**CHANGE ORDER APPROVAL FORM**

PROJECT: 14<sup>th</sup> Street Intersection Improvements CHANGE ORDER NUMBER: 1  
(Hickory to Atlantic) DATE: 10/9/12  
CONTRACT NUMBER: CM1849

Reason for Change Order: Add manhole per RFI No. 1; add regular excavation per RFI No. 7; add RCP per RFI No. 8

Description: Add 1 EA Manhole 7 Type J per RFI No 1 (S-23A), Add 394.00 CY of Excavation per RFI No. 7, Add 4.0 LF of 18" RCP per RFI No. 8.

SHEET NO.  
29

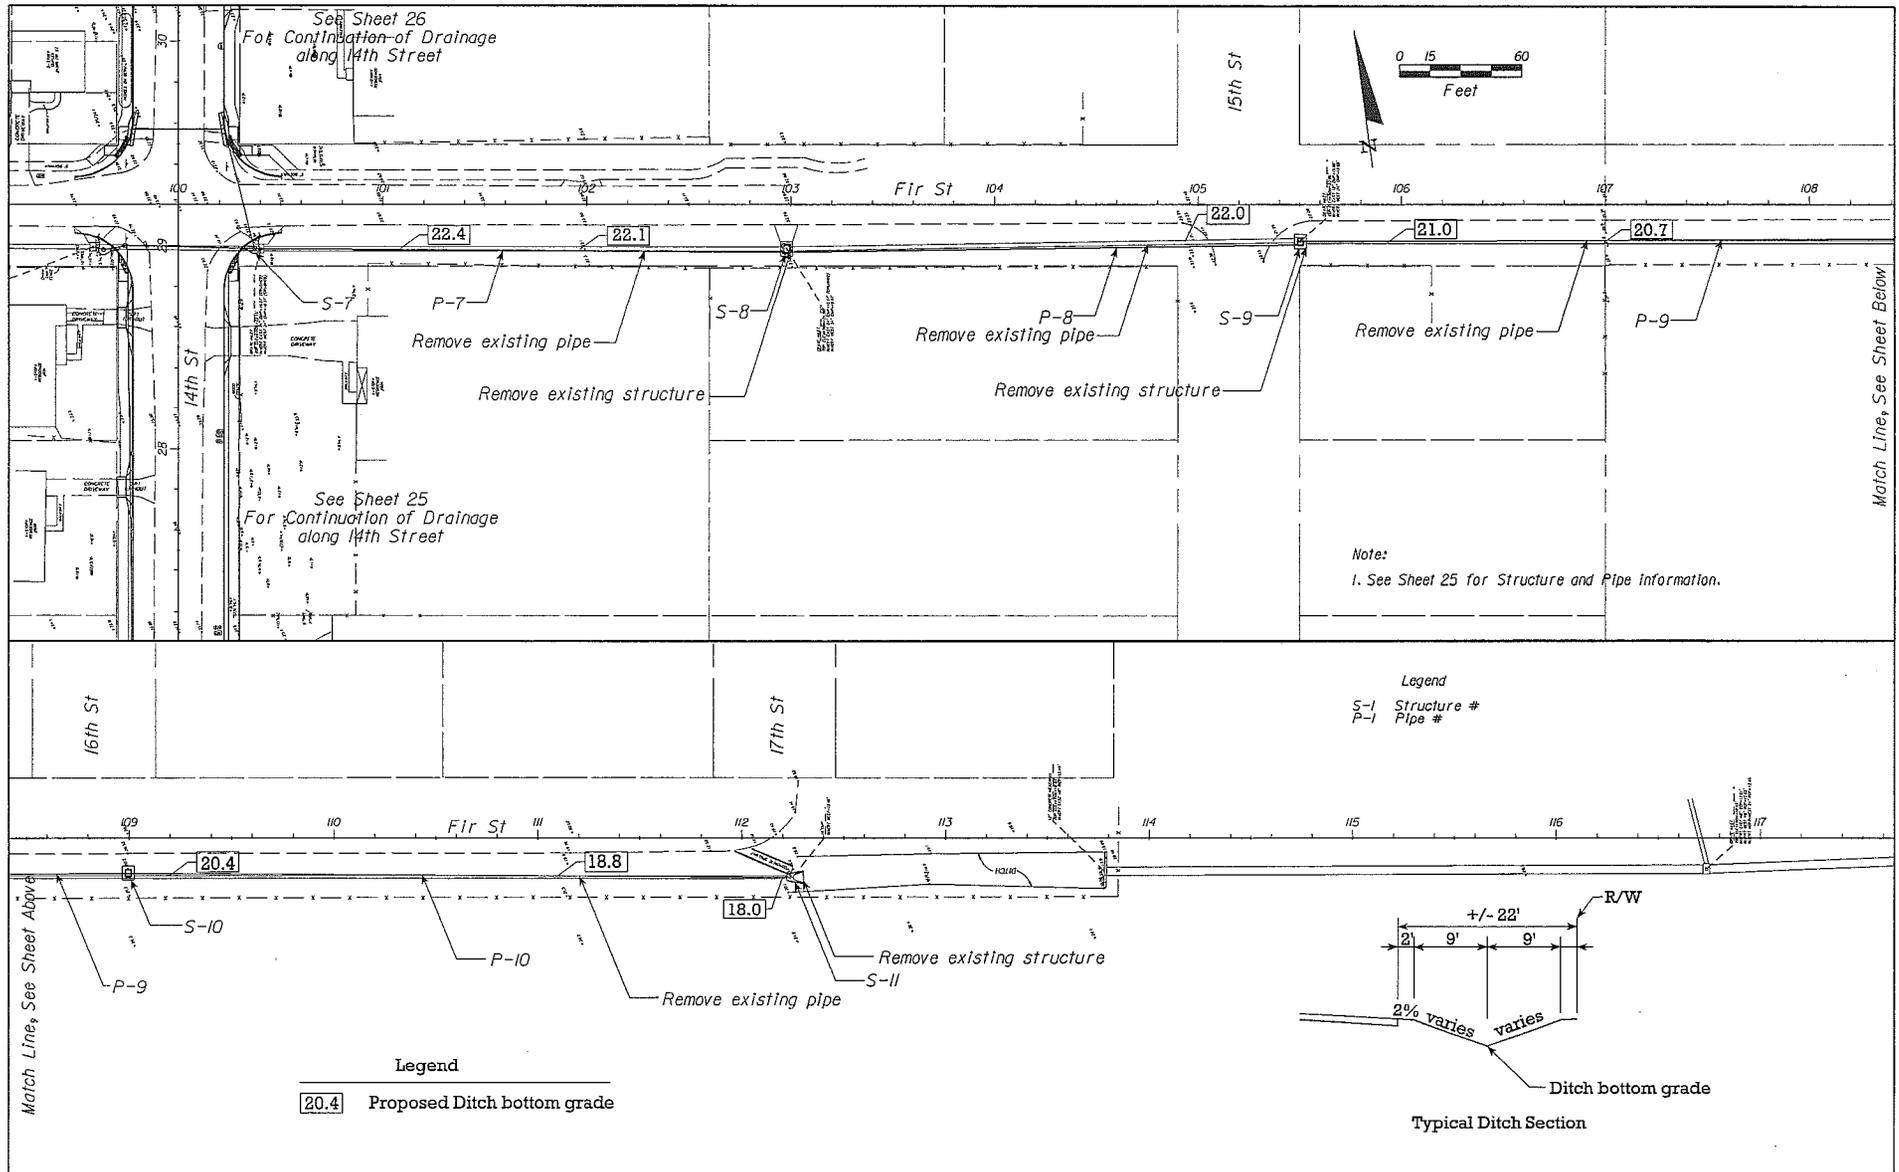
During a review of the plans it has come to our attention there is no typical section or final grade design for the disturbed area along the south side of Fir Street where the pipe is being installed.

Field observations during rain events lead us to believe the lack of grading in this area could be an oversight. Discussions with Kenny Cornell (ETM) would suggest the county would benefit from the construction of a drainage swale along the right of way to channel the runoff between the ditch bottom inlets along the Fir outfall.

Please advise us of what change if any would best suit the owners' needs in this area.

Attached is a revised drainage sheet (Sheet 29). We have added proposed ditch grades (inside the rectangular boxes) as well as a typical ditch section. If there are any questions or conflicts in the field, please notify us immediately.

REVISIONS			
DATE	BY	DESCRIPTION	
8-14-12	DM	Added Ditch Grades

48"DIA P-4 CI # S-6  
1 ea

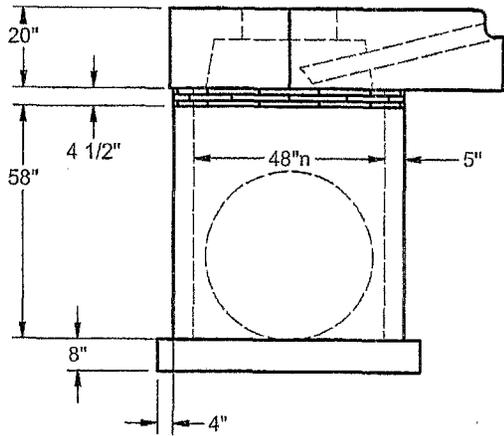
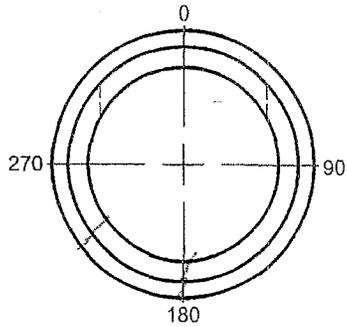
Baker Infrastructure Group request direction on the intent of the existing drainage and drainage structure at the SW Corner of Fir Street and S.14<sup>th</sup> Street.

The drainage plans "sheet #25" do not show an existing storm run nor do they give any direction as to removing an existing structure or tying into an existing structure. Also the shop drawing for S-6 was approved with only one hole which would be from S-5 to S-6.

On sheet 14 of the plan and profile sheets the existing structure and pipe run are shown but also do not give any direction as to how the existing structure, pipe or drainage along Fir street are to be constructed.

Please advise on what needs to be done in this area as we will be setting S-5 today.

The shop drawing for S-6 was approved as noted. I added a 36" opening at 207' for an invert of 16.28 (see attached copy). The existing 24" CMP heading east from the existing structure needs to be removed. A new run of +/- 4' of 24" RCP will then run from the existing structure to S-6. I intend for the existing structure to remain, however if that is not feasible, I would like to meet in the field to solve the problem.

NOTE: Tied in w/18" RCP TO MATCH EXISTING. (COV)
